UNITED STATES PATENT AND TRADEMARK OFFICE

APPLICATION NO.	FILING DATE	FIRST NAMED INVENTOR	ATTORNEY DOCKET NO.	CONFIRMATION NO.
10/054,257	01/22/2002	Frederick R. Bean	TN-2239	3692

Office Action Summary

DETAILED ACTION

Fig. 6

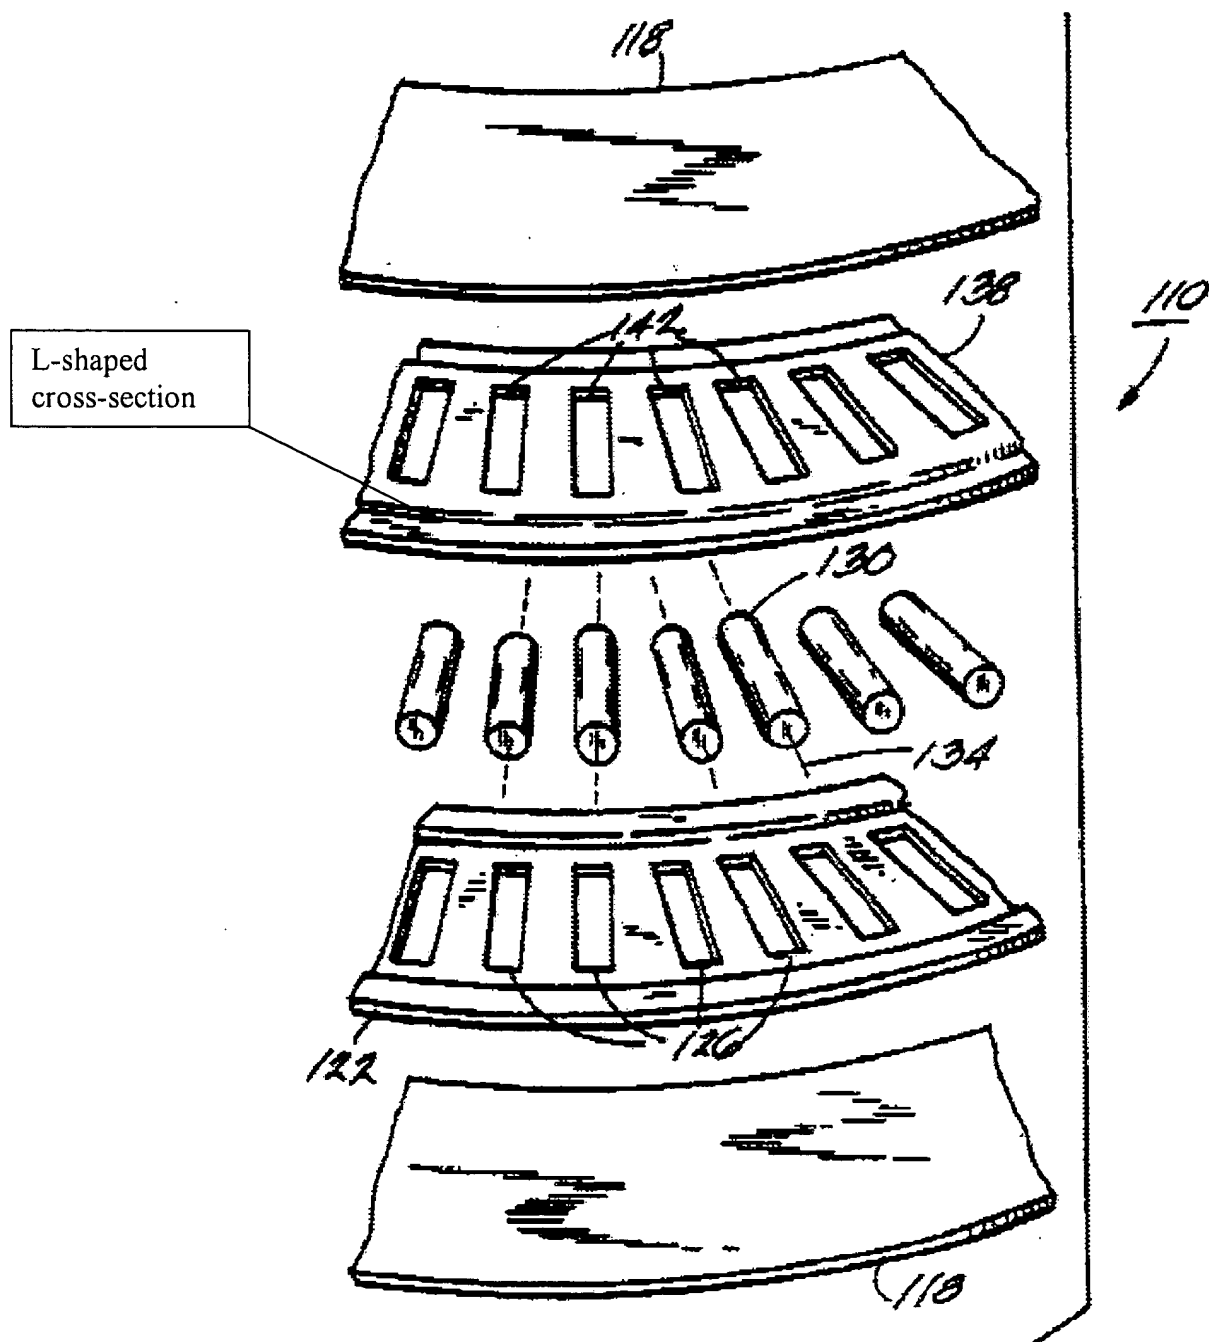
Regarding claims 1-5, Brault teaches a saw assembly comprising a base 14 having a circular well 66, a table 182 rotatably attached to the base, a saw assembly 150 and a wearing ring 138 having a L-shaped cross-section. See Figs. 1 and 5-7.

Regarding claims 6 and 7, a wall 106 extending from the well is best seen Fig. 5.

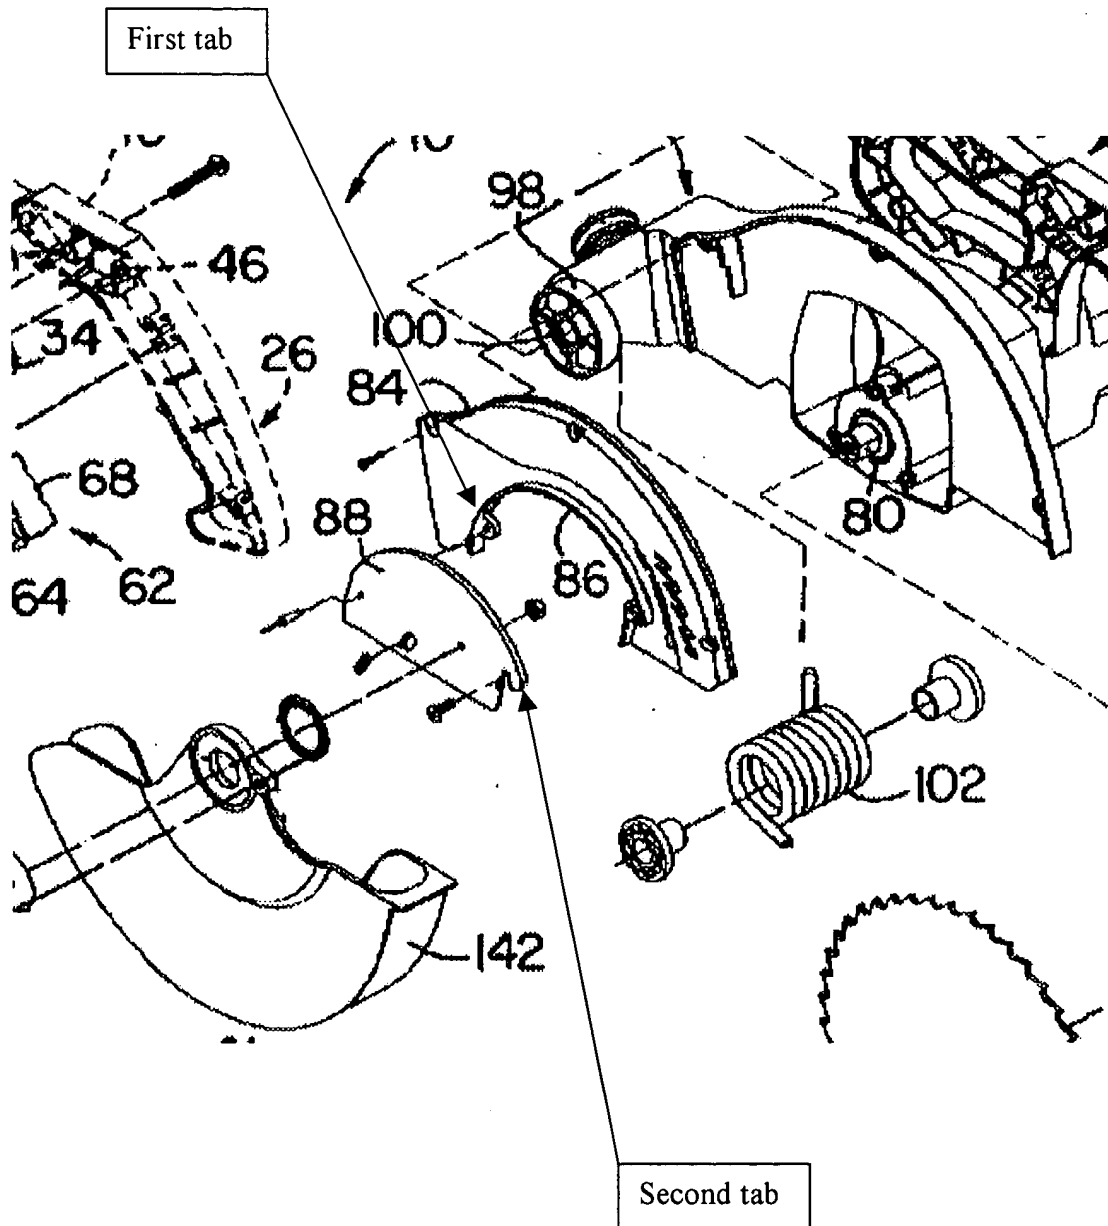
Stumpf teaches a miter saw assembly comprising a base 12, a table assembly 14 pivotably attached to the base, a fixed fence 48 and sliding fences 132 having a hole 178 for fixing an end stop fixture 68 thereto. See Figs. 1, 4, 5, 8A and 8B.

It is noted that providing an appropriate hole's size 176 to accommodate the screw 68 involves routine skill in the art.
